## ADDENDUM No. 1

### ITB No. 4669 - 2021 MISCELLANEOUS UTILITIES PROJECT

SCALE: 1" = 40'

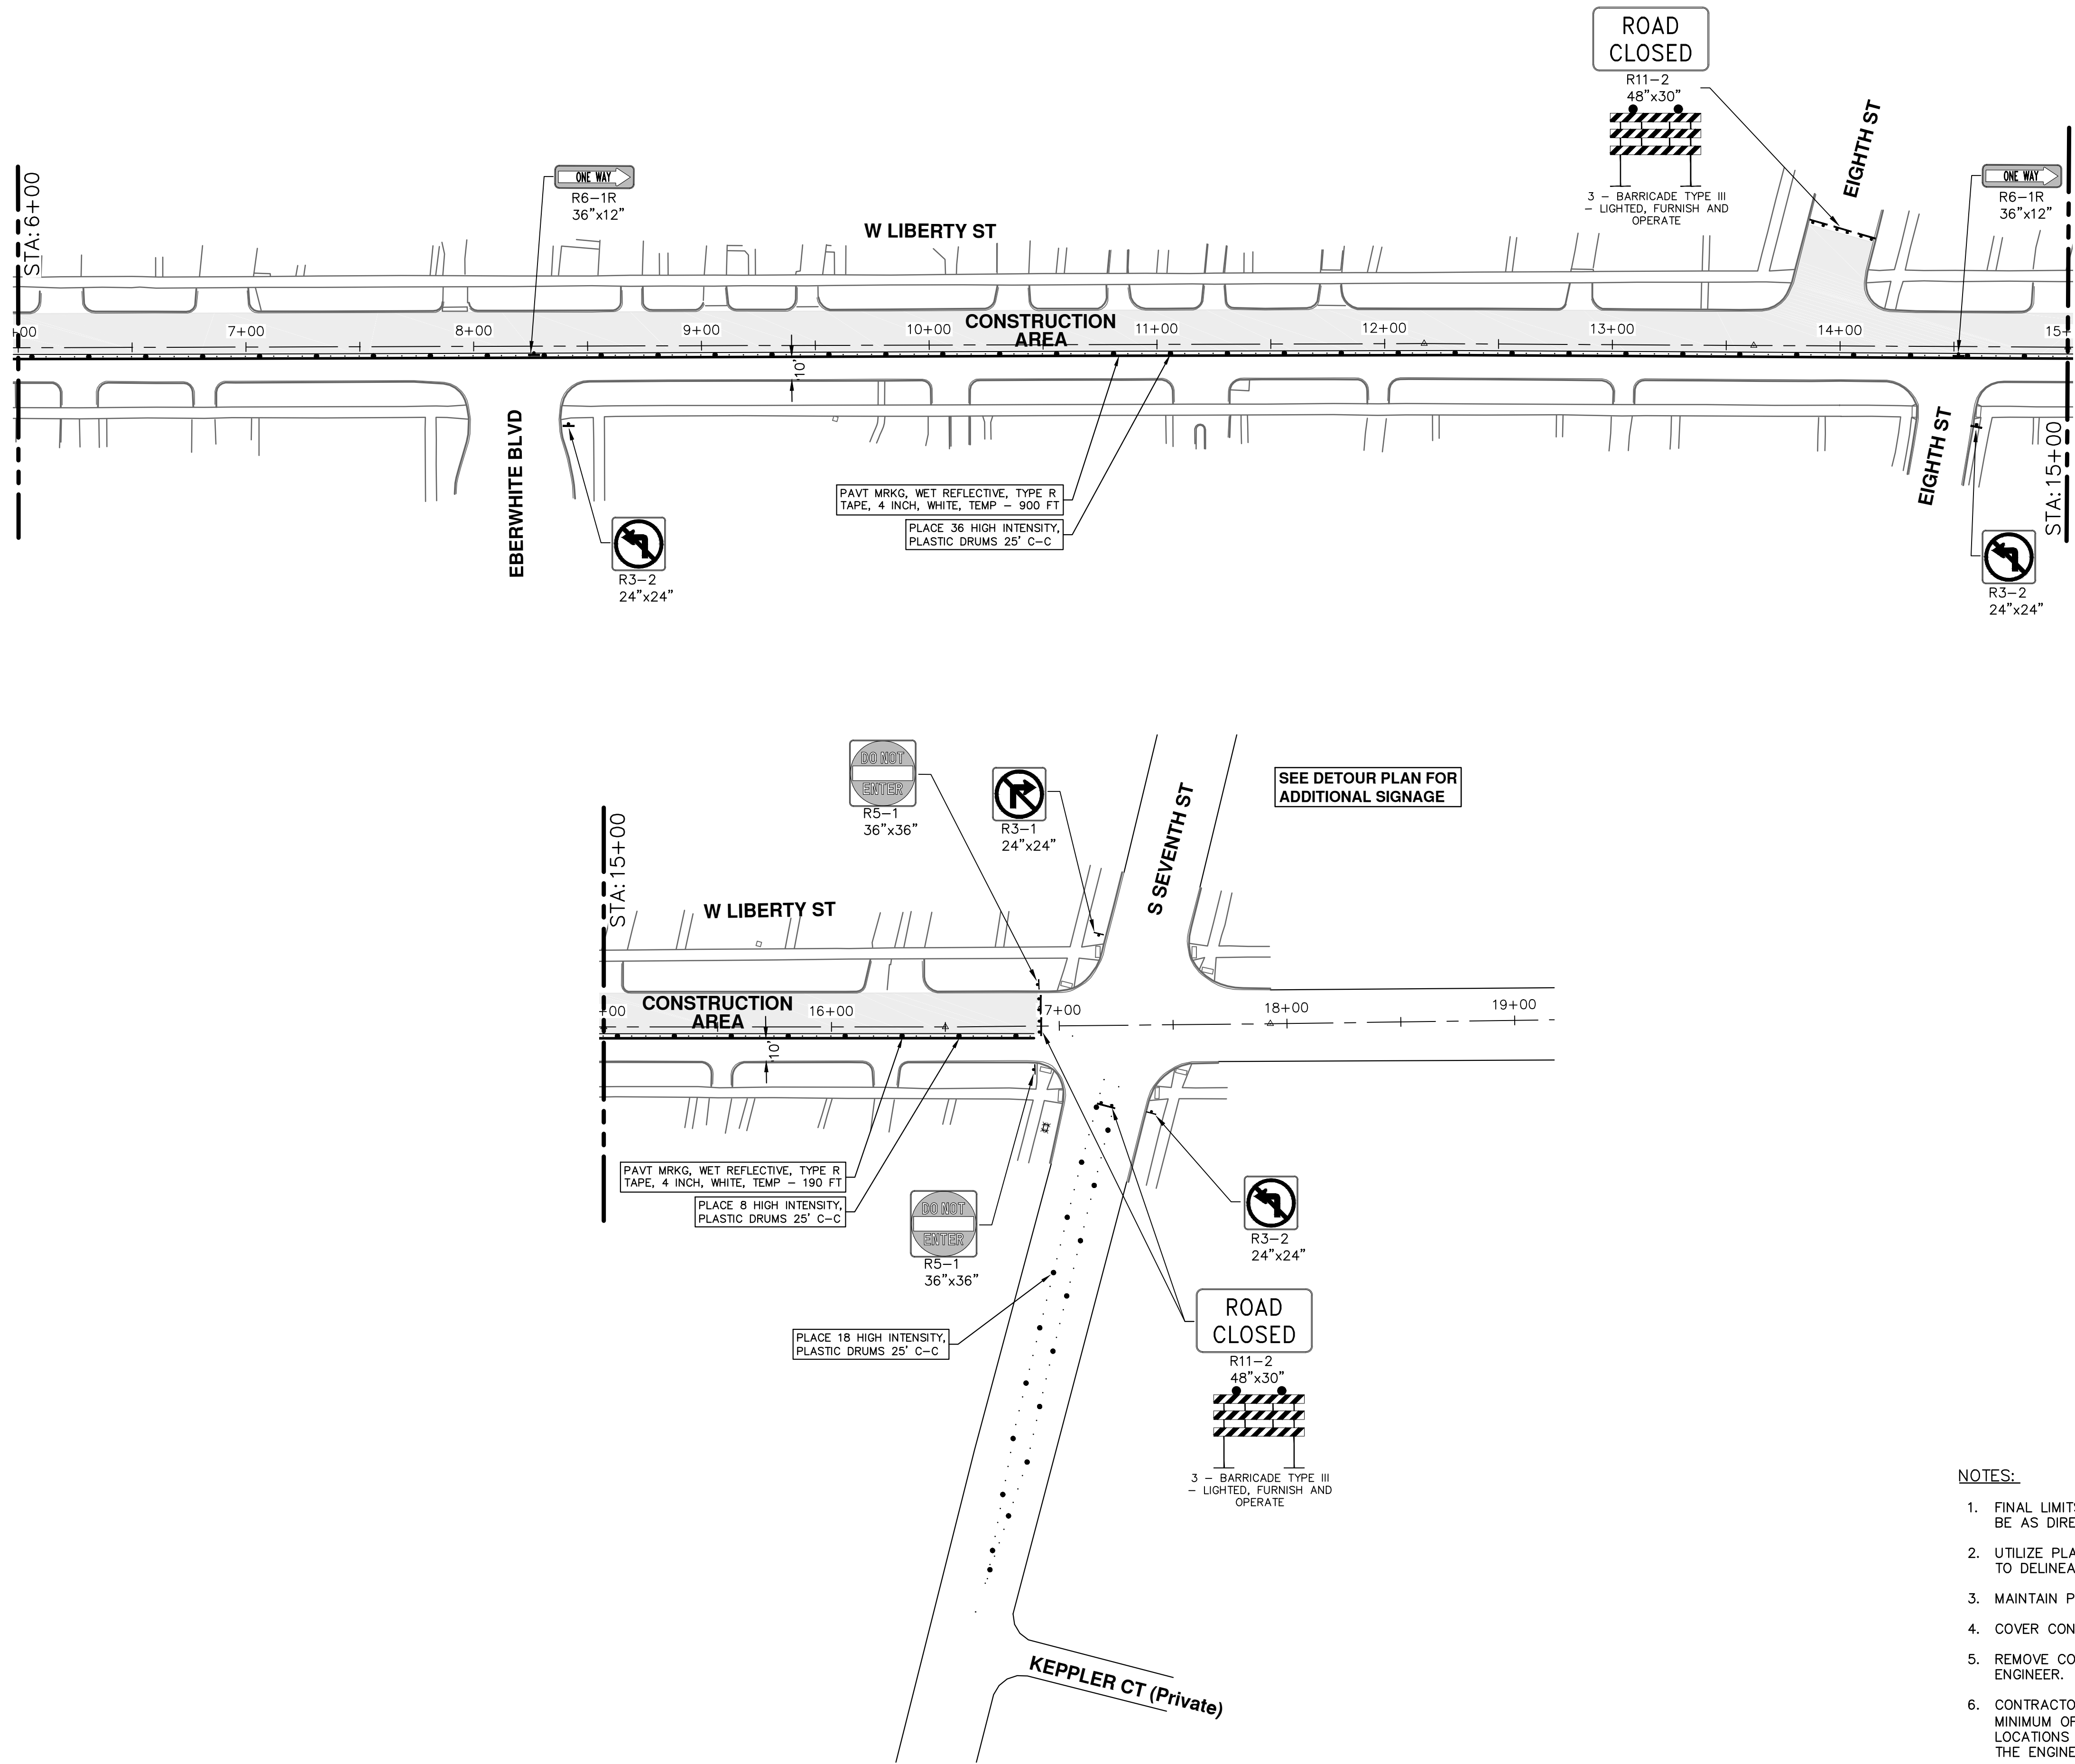
Answer 13: The proposed duration has been revised.
- Question 14: I do not see a MOT plan for the north side (westbound) West Liberty Street construction. I assume that the provided MOT plan will be flip flopped to maintain eastbound traffic when this work is taking place, correct?  
Are the long side water services and transverse water main items that cross West Liberty Street to be performed under traffic, or built part width to the construction limits during a "phase"? Please advise.

Answer 14: West Liberty Street MOT plans have been added for maintaining eastbound traffic on the south side of West Liberty Street.

CITY OF ANN ARBOR - PUBLIC SERVICES - ENGINEERING  
2021 MISC. UTILITIES PROJECT  
CREST AVE - W HURON ST 8-IN WATER MAIN CONNECTION  
STA. 0+26 - STA. 1+14

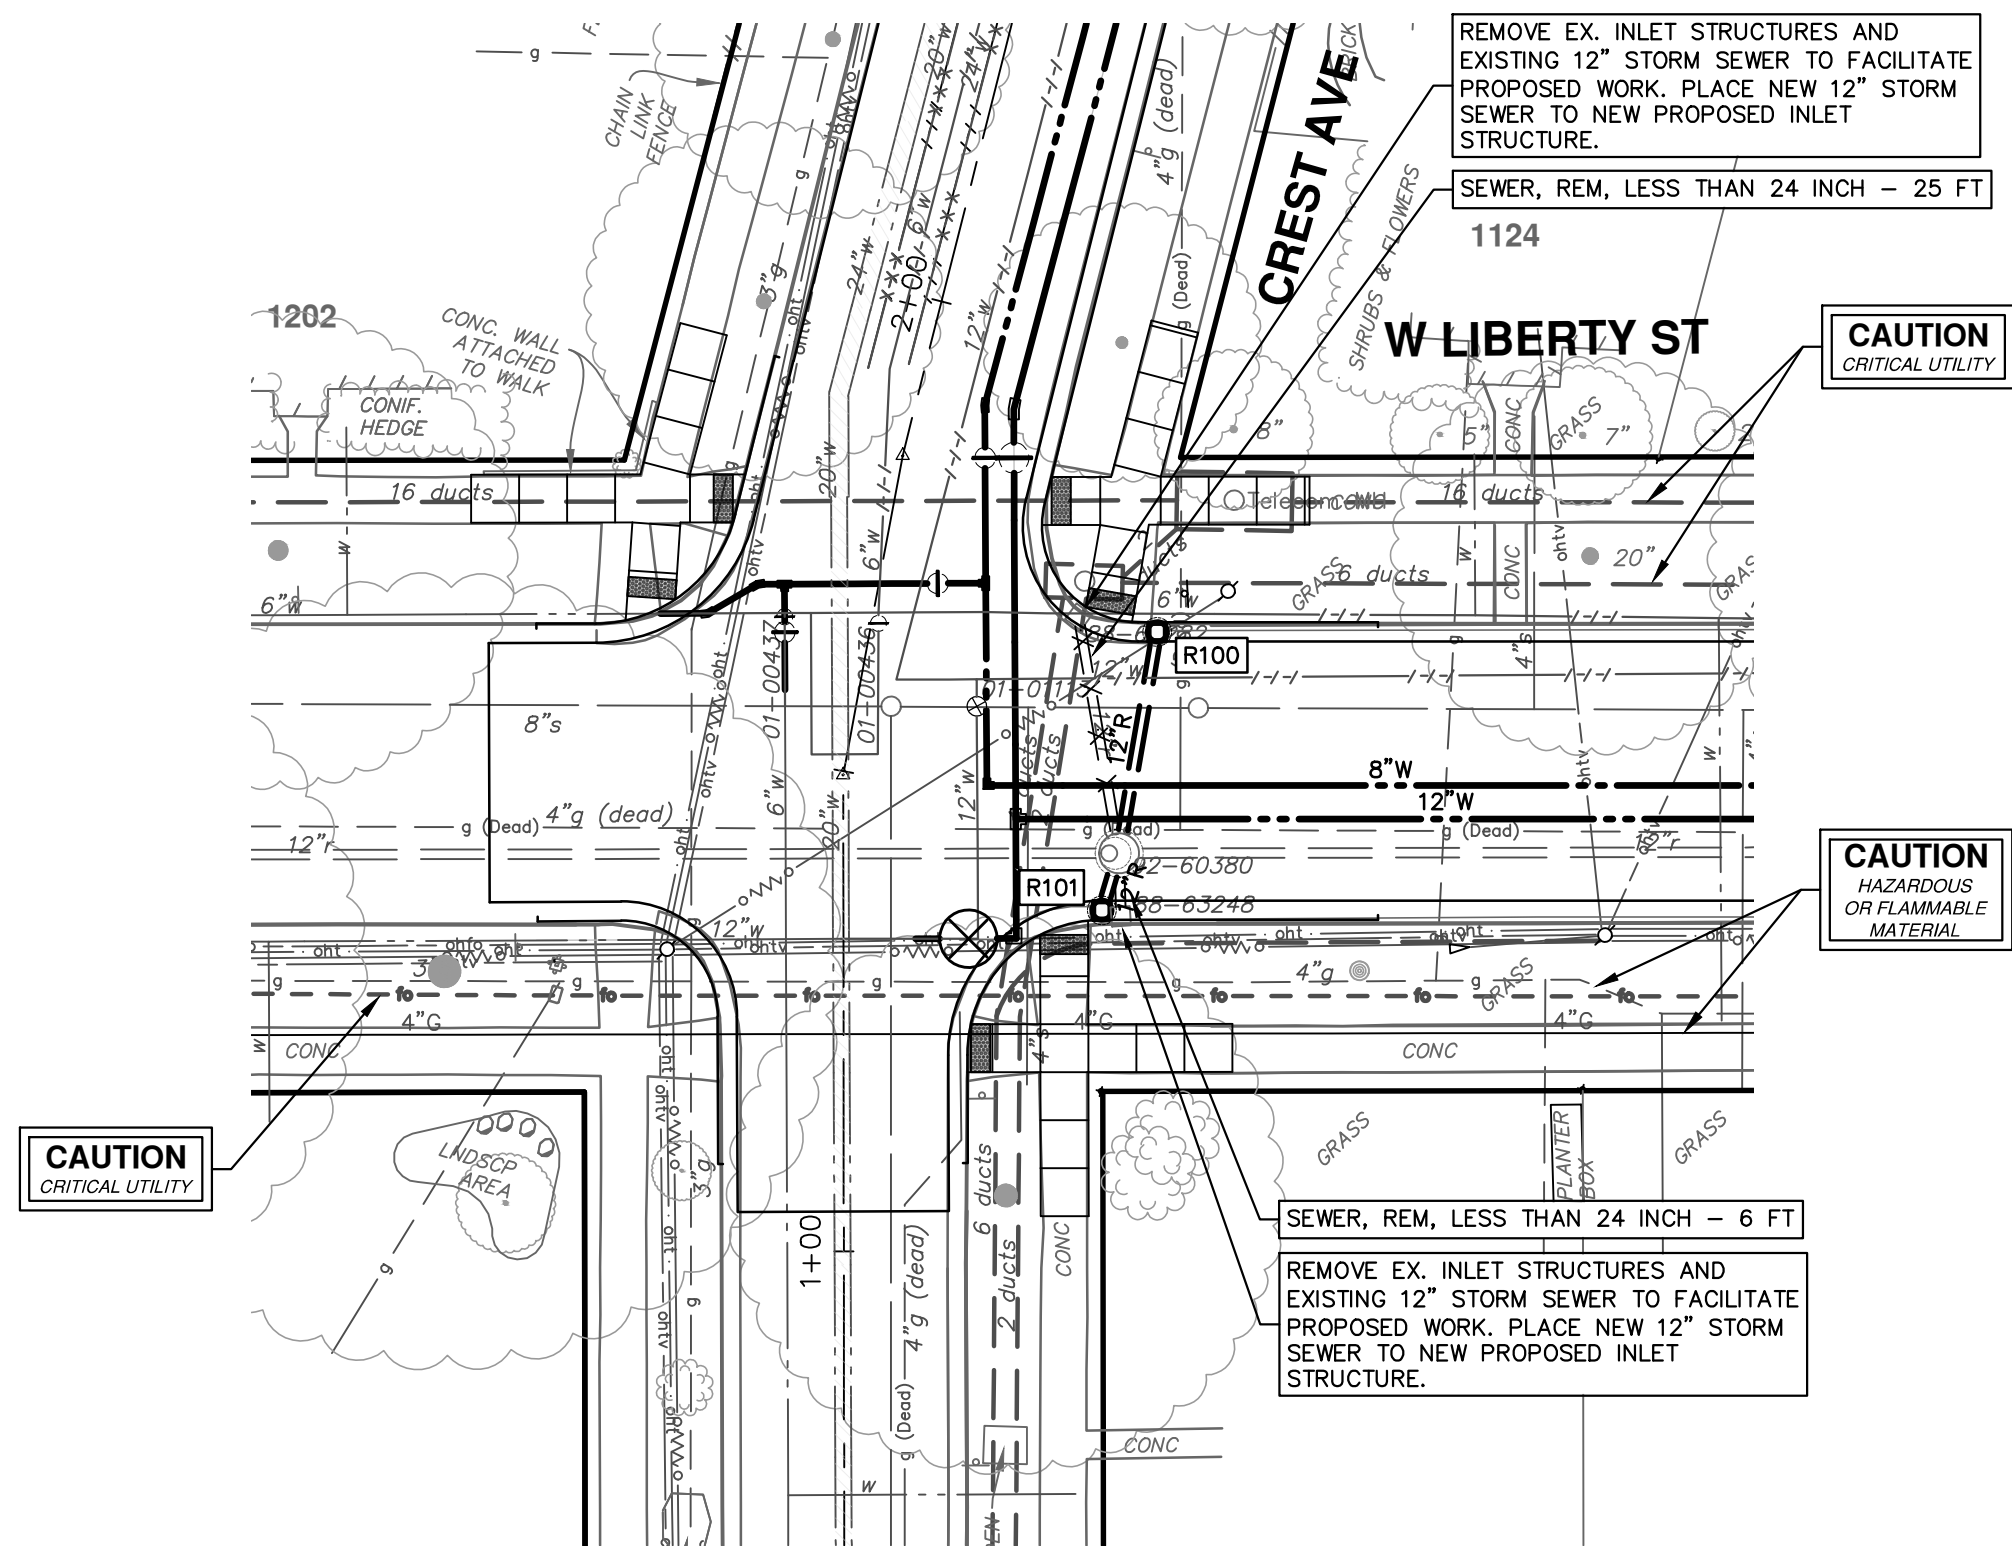
Drawings/40, 41	(Renumbered Sheets 44, 45) - Added GVIW's and removed GVIB's
Drawings/42	(Renumbered Sheet 46) - Work zone quantities
Drawings/50	(Renumbered Sheet 54) Sheet 54 – Added GVIW, removed GVIB and changed trench detail call-out
